AMENDMENT(S) TO THE DRAWINGS

REMARKS

Amendments to Specification and Drawings

Fig. 3

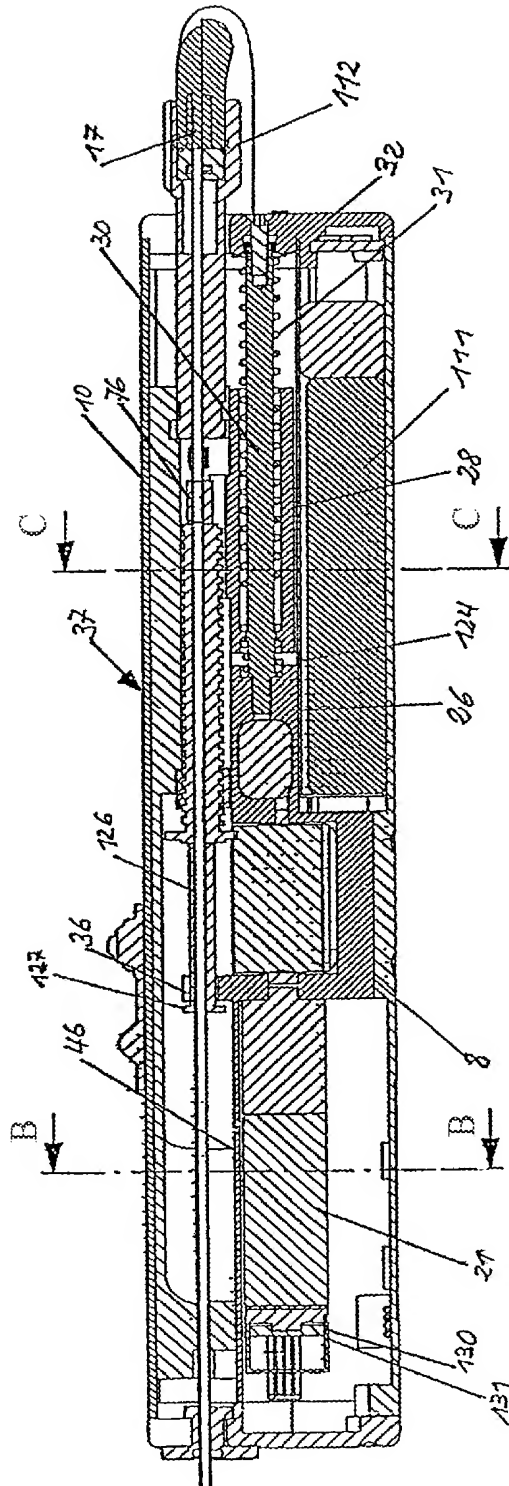
Please amend Figs. 3, 4, and 5 as indicated in red on the attached Annotated Sheet. A Replacement Sheet presenting replacement figures which incorporate the desired changes is also attached in the Submitted Drawings section of this amendment.

U.S. Patent Application No. 11/680,882 is a continuation of the present application. During recent prosecution in U.S. Patent Application No. 11/680,882, the drawings and specification were amended to correct errors. Accordingly, Applicants have amended the specification and drawings in the present application to be consistent with the amendments made in U.S. Patent Application No. 11/680,882.
